INDESIT company

Model type:
ARSD129EU

Commercial code:
F054399

1140350B Exploded views

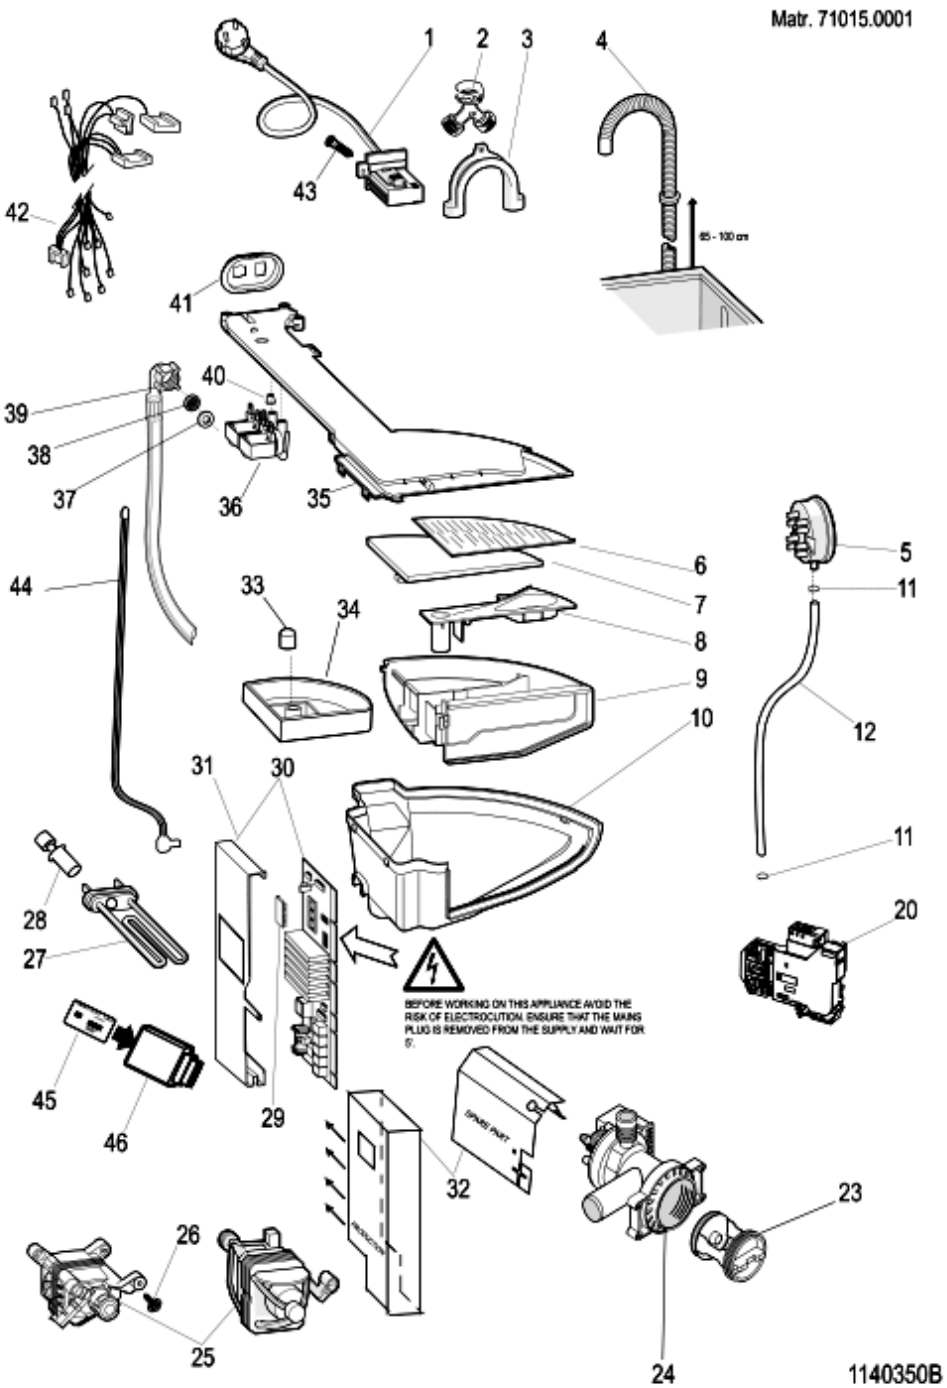
n4008f00: Thermic link wire removed on three-phase motor

When you assist the premodification models using the new motor code you MUST use the thermic link wire code C00265838.

1180270C Exploded views

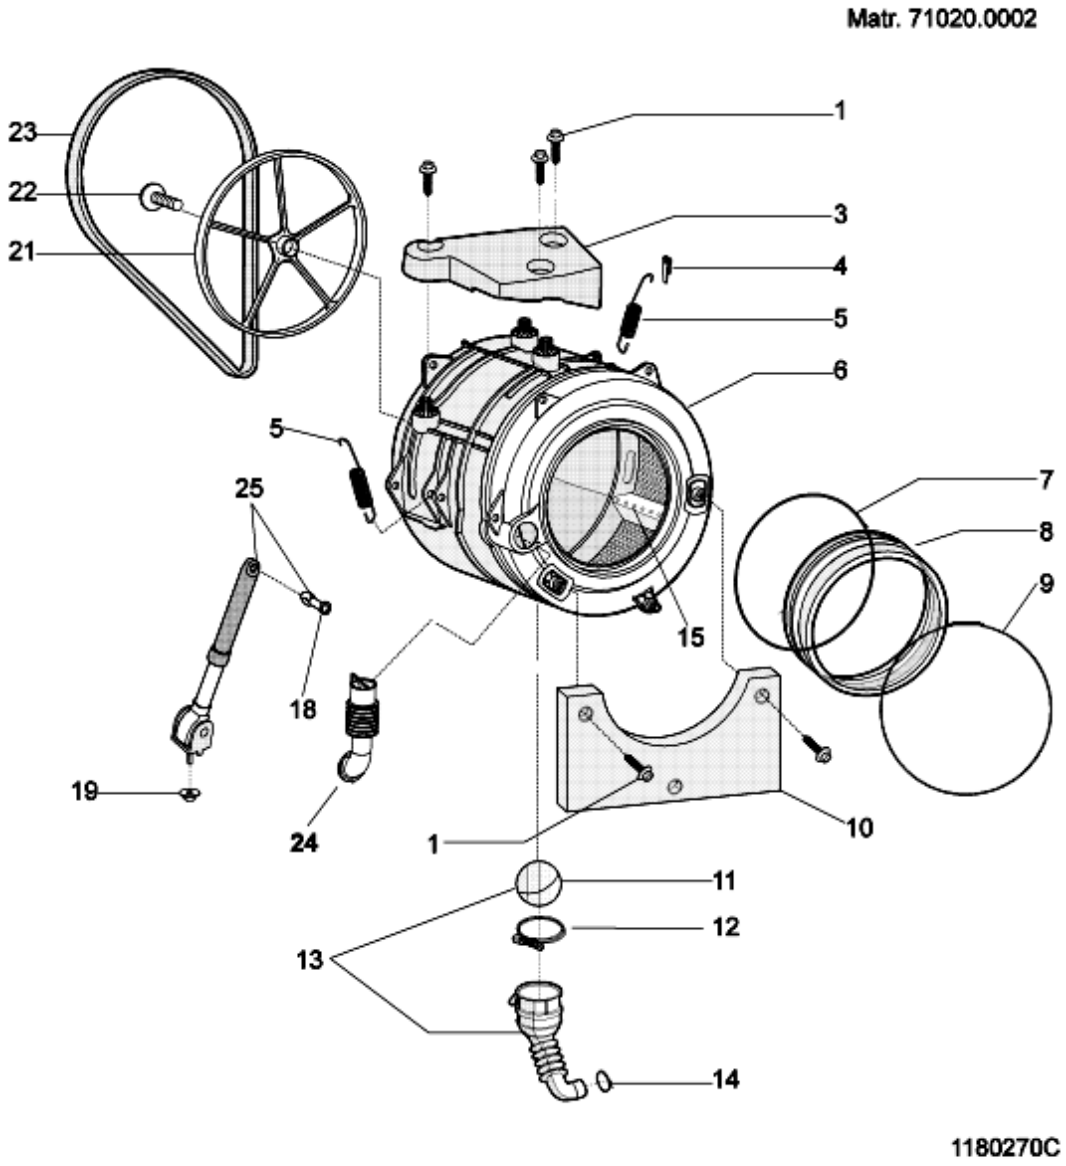
n4014c02: TUB ASSEMBLIES WITHOUT HEATING ELEMENT

Starting from week 10/2014 all tub assemblies involved in this technical notice will be provided without heating element.
The tub assemblies will not have the heating element clip (already removed in production starting from the end of 2012); the mechanical assembly of the heating element to the tub will be absolutely unchanged.
We suggest, when possible, to keep the heating element assembled in the assisted tub.

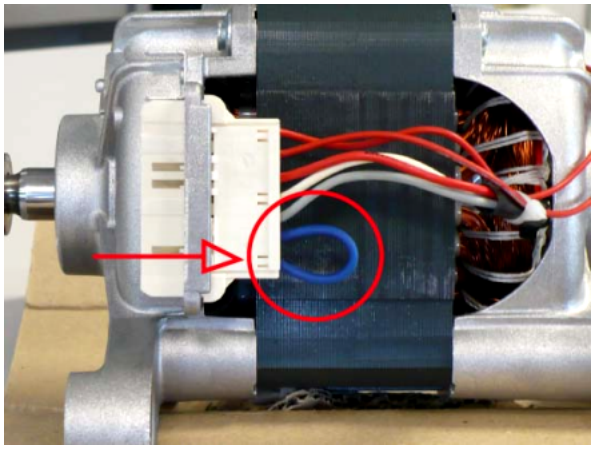
Attention!

The spare part warehouses will manage the premodification motor until the end of the stock, after they will be replaced with new ones and thermic link wire.

TRIPHASE P40 46 L – INOX TUB
C00265827 new motor without thermic link wire - C00116103 premodification motor with thermic link wire

TRIPHASE P40 46 L – PLASTIC TUB
C00265826 new motor without thermic link wire - C00142390 premodification motor with thermic link wire

TRIPHASE P50 52 L
C00265829 new motor without thermic link wire - C00142205 premodification motor with thermic link wire

TRIPHASE P32 46 L TOP LOADING
C00265832 new motor without thermic link wire - C00262375 premodification motor with thermic link wire

TRIPHASE P40 46 L TOP LOADING
C00265834 nuovo new motor without thermic link wire - C00112739 premodification motor with thermic link wire

In the attached image you can see the fixing of thermic link wire in the motor therminal box.
